Notice of Allowability

10/668,794

ECKSTEDT, PAUL D.

EXAMINER'S AMENDMENT

FIG. 2

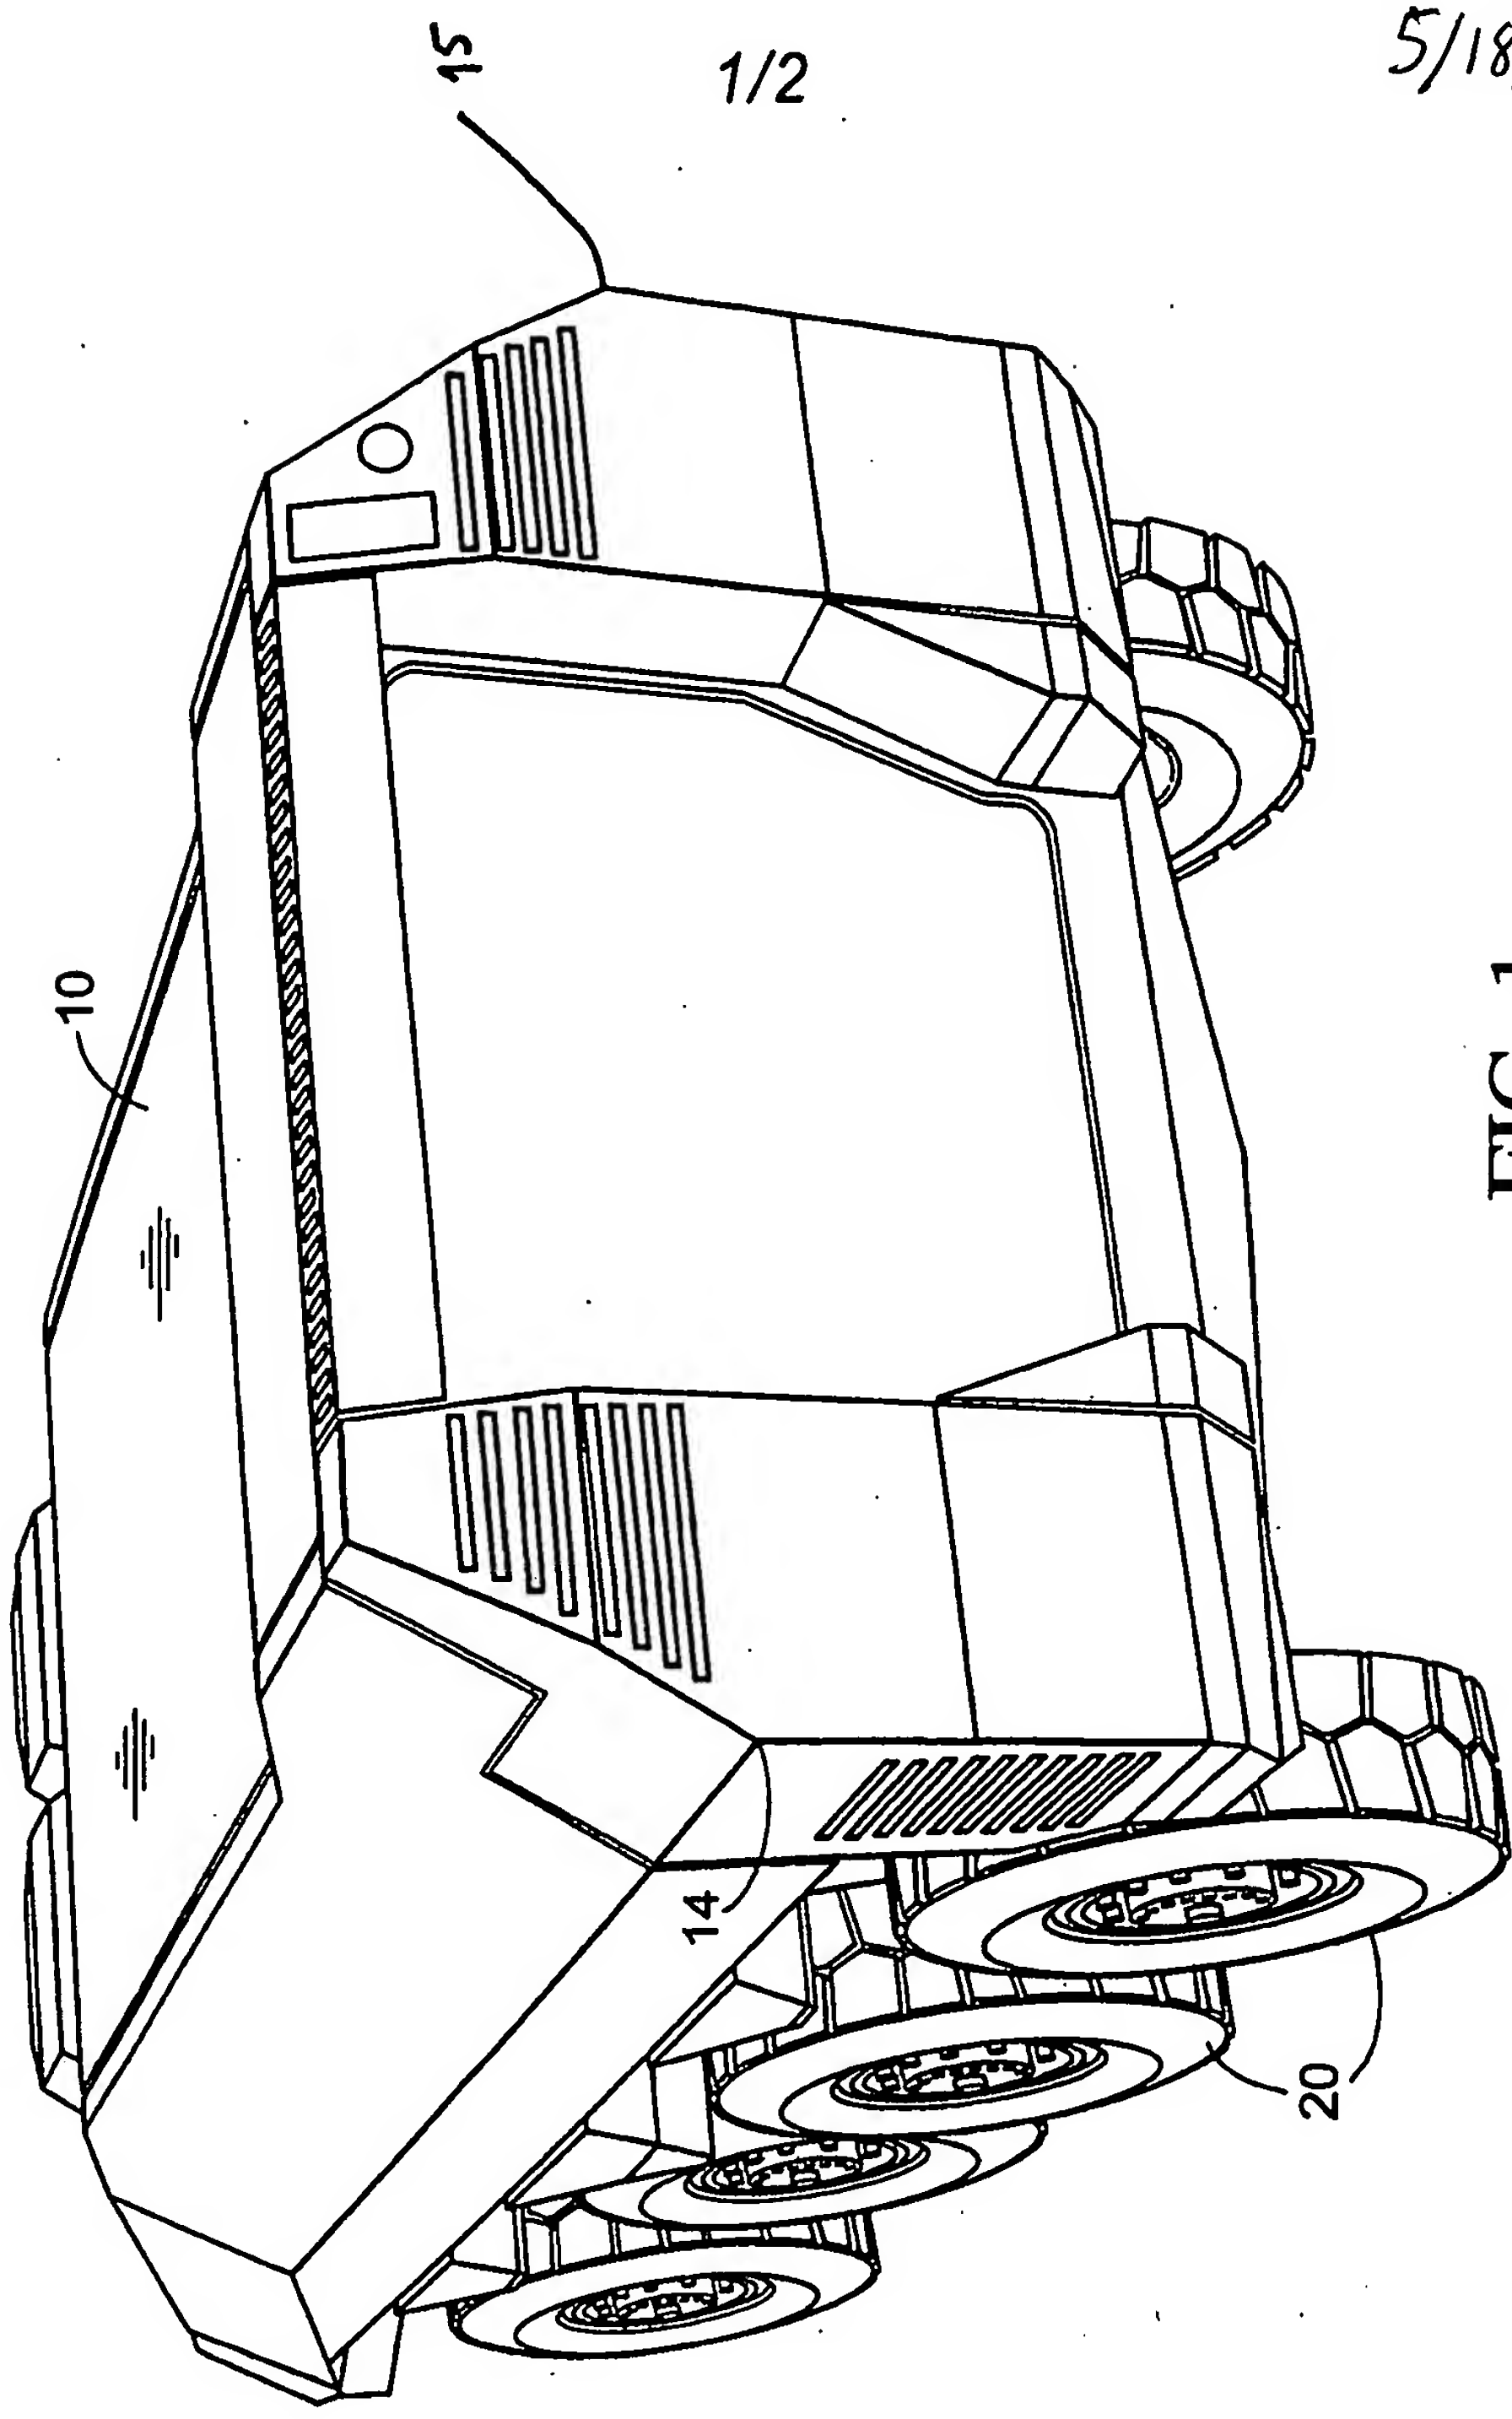
- a. On page 4, line 4, after "drive motors" was inserted, --schematically illustrated at 50--, as Rule 37 CFR 1.83 states that all claimed features must be illustrated, and the motor(s) were not illustrated.
- b. In claim 1, lines 5-6 "wherein the turbine engine" was deleted to correct grammar.

2. The following changes to the drawings have been approved by the: Figure 2 was amended to add reference numeral 50 schematically representing an electric motor. In order to avoid abandonment of the application, applicant must make these above agreed upon drawing changes.
